# Illustrated Parts List - IPL Update

**372XP**

1. Incorporation of new Fuel tank.  
Reason: New tank vent assy.
2. New spare part: Tank vent assy 501 15 29-01

## 1. Fuel tank

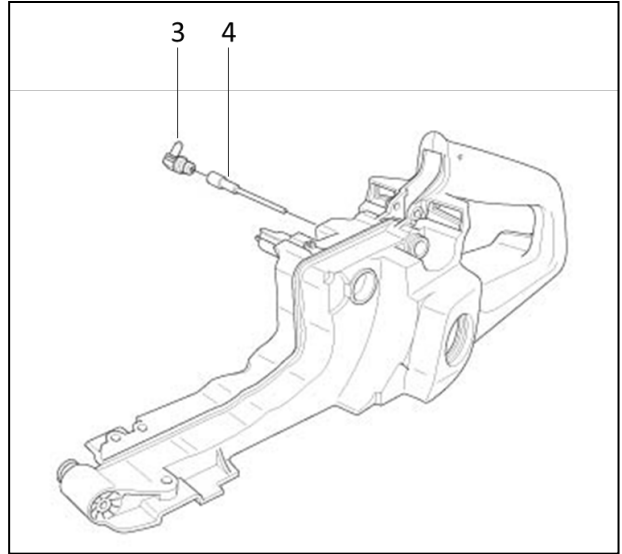
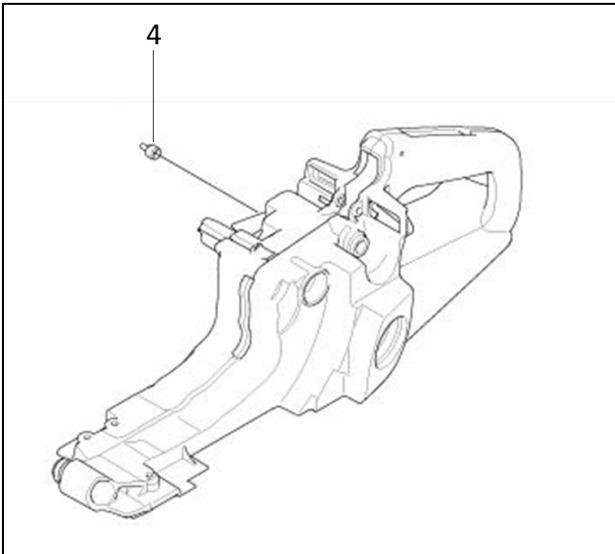
544 11 40-13 Fuel tank replaces 544 11 40-07 Fuel tank (pos. 1).

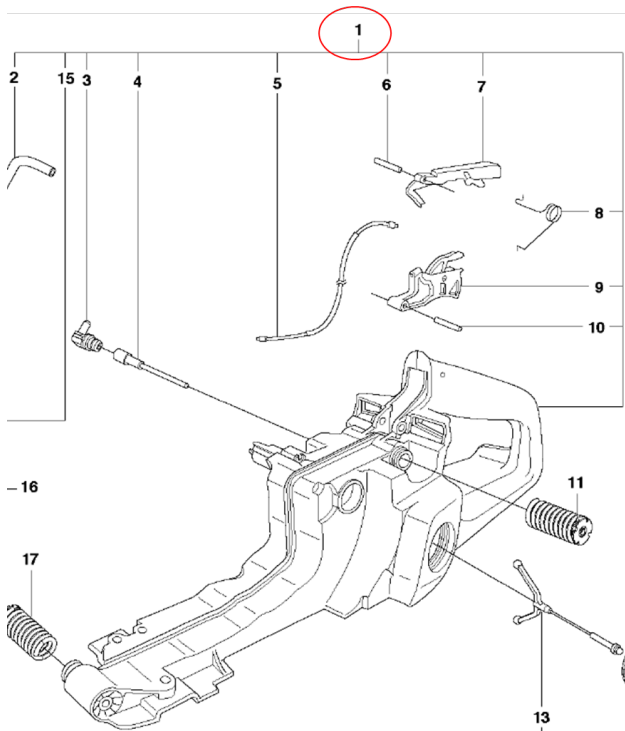
501 15 29-01 Tank vent assy replaces 537 09 22-01\* Tank vent assy (pos. 4).  
537 09 93-01\* Connection bend removed (pos. 3).  
*\*Remains as spare part.*
